RM Phase 7 (Units 15-18) – Ref. 25/0176

Indurent response to Highway and Landscaping Comments

June 2025

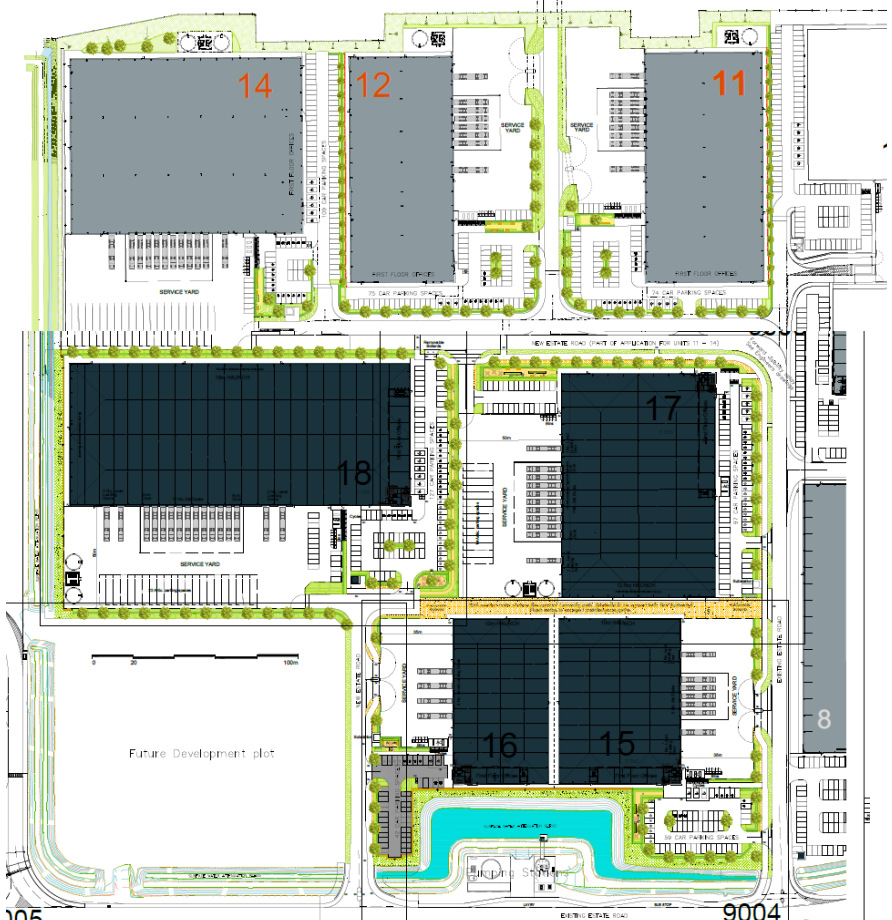
Structural planting is shown on the boundary with units 11,12,14 to the east which is welcome.	Noted
There is a lack of any structural planting along the north of unit 18, however I think this continues treatment along the north of unit 14 which I believe has been approved.	The landscaping along the existing reen to the north of the phase continues on from the approved landscaping for Units 11-14 which was approved under application ref. 24/0983. The proposal landscaping along this boundary therefore ties in with the approved landscaping along this boundary as shown below:  The diagram is a detailed site plan for a residential development. It shows several rectangular building footprints, each labeled with a unit number in orange: 14, 12, 11, 18, 17, 16, and 15. Unit 18 is a large dark grey rectangle in the center-left. Units 14, 12, and 11 are at the top. Units 17, 16, and 15 are at the bottom. A large white area on the left is labeled 'Future Development plot'. The plan is surrounded by roads: '105' on the left, '9004' on the bottom right, and '10011' on the far right. Landscaping is indicated by green lines and symbols for trees and shrubs along the boundaries and between units. Parking spaces are shown as small rectangles. A scale bar at the bottom left indicates 0, 20, and 100m. The plan also shows various service yards, access roads, and other infrastructure details.
